JRPP No	2010NTH030
DA Number	DA10/0707
Local Government Area	Tweed Shire Council
Proposed Development	Proposed mixed use motor showroom car repair station and commercial premises - staged development (JRPP) at Lot 16, 20 Section 4 DP 2379; Lot 1 DP 1014402; No. 58 Recreation Street Tweed Heads; No. 169-171 Boyd Street Tweed Heads; No. 60 Boyd Street Tweed Heads; Boyd Street Tweed Heads.
Applicant	Bruce Lynton Pty Ltd
Number of Submissions	1
Recommendation	Approval, subject to conditions of consent
Report by	Colleen Forbes, Acting Coordinator Development Assessment, Tweed Shire Council

Assessment Report and Recommendation

Development Application DA10/0707 for a proposed mixed use motor showroom car repair station and commercial premises - staged development (JRPP) at Lot 16, 20 Section 4 DP 2379; Lot 1 DP 1014402; No. 58 Recreation Street Tweed Heads; No. 169-171 Boyd Street Tweed Heads; No. 60 Boyd Street Tweed Heads; Boyd Street Tweed Heads.

Figure 1: FSR Bonus provisions – landscaped court (shown in green)

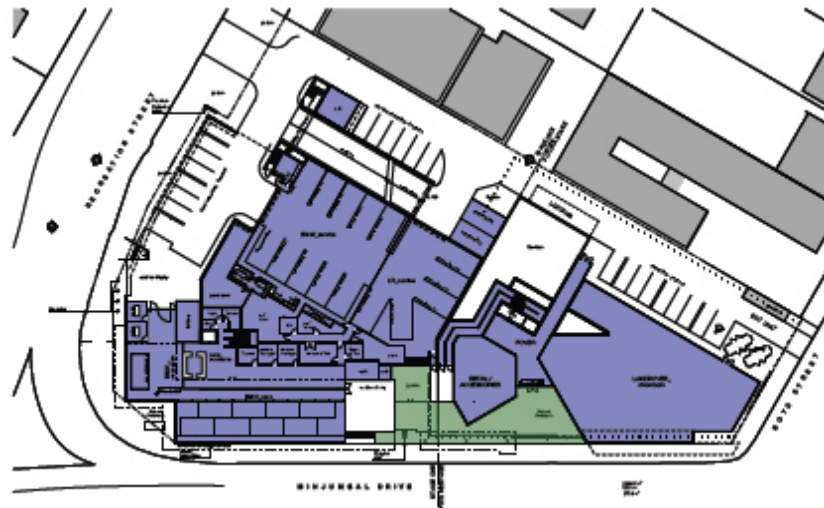
Items b and c above are being utilised by the applicant in terms of providing a publically available community space in the form of a landscaped court (identified in green in Figure 1 below) and commercial office space within Stage 2 of the development.

Figure 2: Extent of Overshadowing of Adjacent Reserve

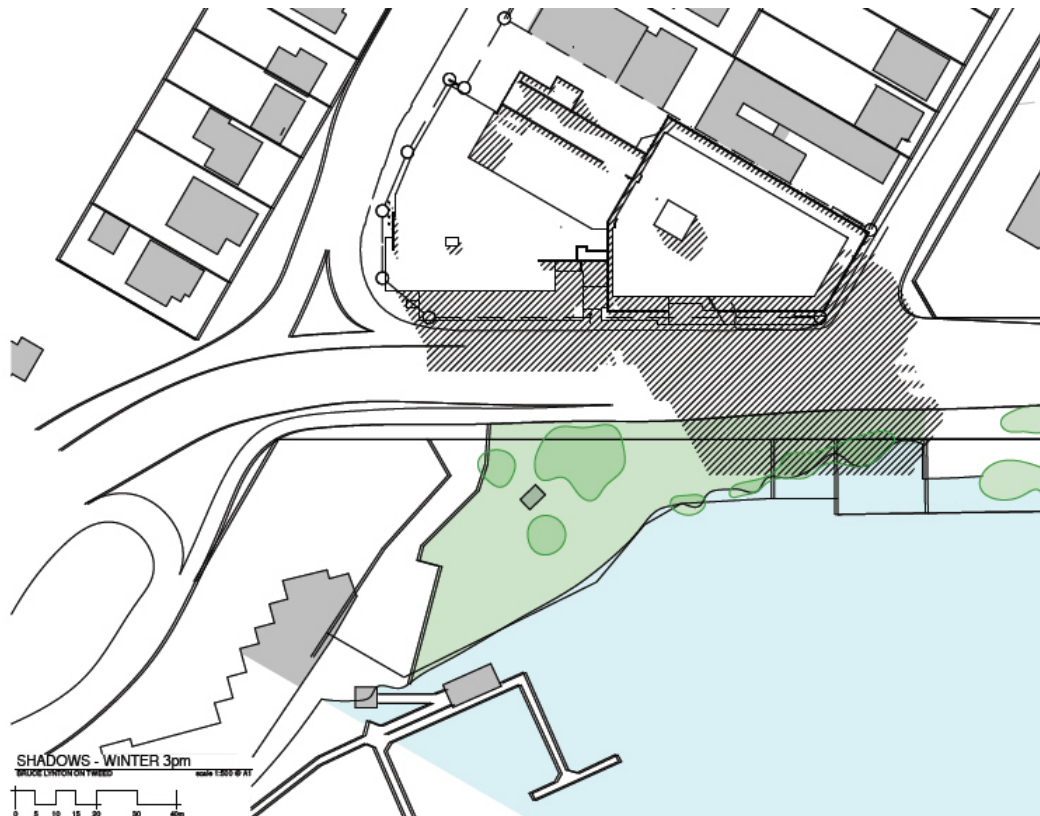
The applicant has acknowledged that the proposed development will result in overshadowing of the reserve at 3.00pm midwinter, with no overshadowing occurring during midsummer. See Figure 2 below, which indicates the extent of overshadowing over Wharf Street and across part of the reserve. The expected shadow cast by the proposed development has been estimated as approximately 380m² in area (8m deep x 48m wide). This equates to approximately 11.5% of the reserve.

It should be noted that the area where the shadow line will fall is largely unusable area in terms of recreation purposes. As noted in Figure 3 below, the portion of the reserve in question is either a pump station, concrete footpath or a narrow band of grass between the footpath and the rock revetment wall at the waters edge.

Figure 3: Overlay of Shadow Line on Aerial Photo (shown in pink)

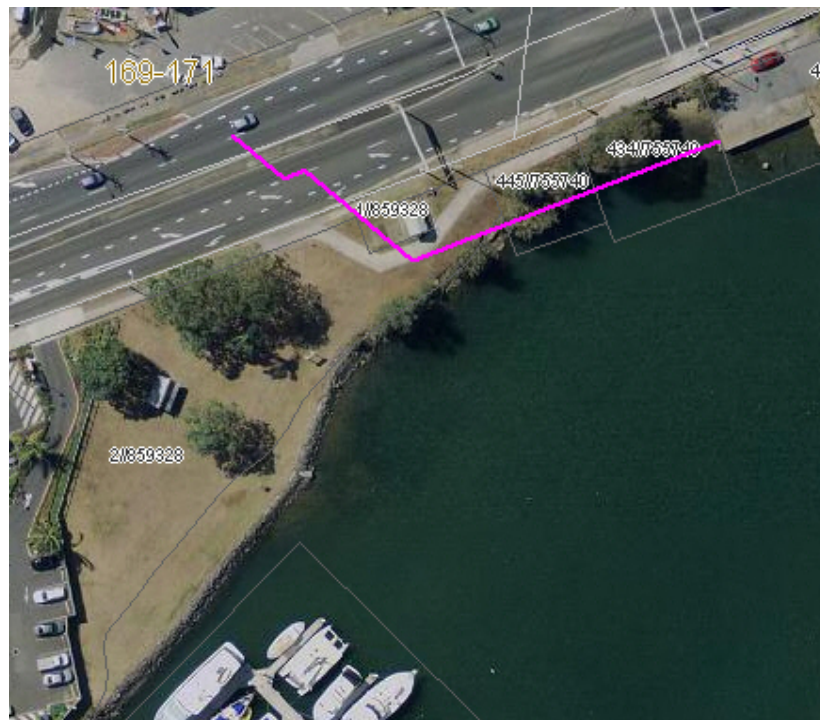
Figure 3 above indicates the line of overshadow impacts on very little of the usable / recreational area of the reserve. In addition, the proposed development is not considered to impact upon the visual quality of the coastal environment; there is no beach at the reserve; water quality is not considered likely to be impacted upon by the minor overshadowing of the reserve; the proposed overshadowing will not increase the risk to people and property resulting from coastal processes; there is not likely to be any change to coastal processes resulting from the development; and the proposed overshadowing will not impact on the natural areas. Therefore, it is Council's opinion that the objectives of the standard are achieved, notwithstanding non-compliance with the standard.

Figure 3 above demonstrates that the proposed overshadowing of the reserve falls over an area that is largely covered by concrete (footpath, pump station etc). The impact of shadow upon this portion of the reserve is considered to be negligible.

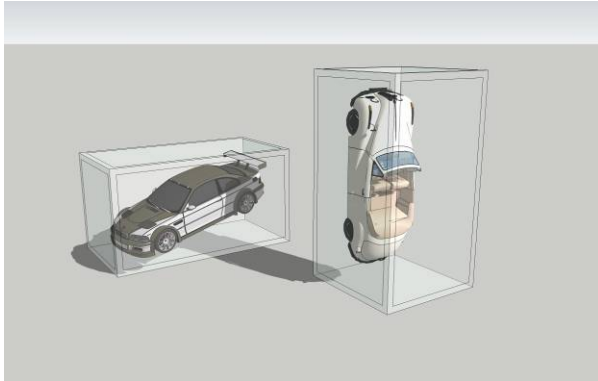
Previous comments also raised concern in relation to the western façade of stage 02 which is most apparent travelling north off Boyd's Bay Bridge in terms of it being a large blank detail-less elevation. The vertical bands of glazing within this elevation (aligning internally with a kitchenette area and circulation corridor of indicative floor plans) somewhat break this elevation. This elevation could be further detailed with bands of glazed off-white tiles corresponding with floor levels reflecting light particularly in the afternoon.

It is however conceded that the proposed architectural language of the building, which includes the continuous horizontal and vertical planes offset by the lightness and transparency of glazed façade and layering of the perforated aluminium screens, provides an overall form and material composition generally acceptable to this site. It is further acknowledged that due to the orientation (west facing) and in consideration of the need to reduce heat loads on the building this elevation needs to be solid.
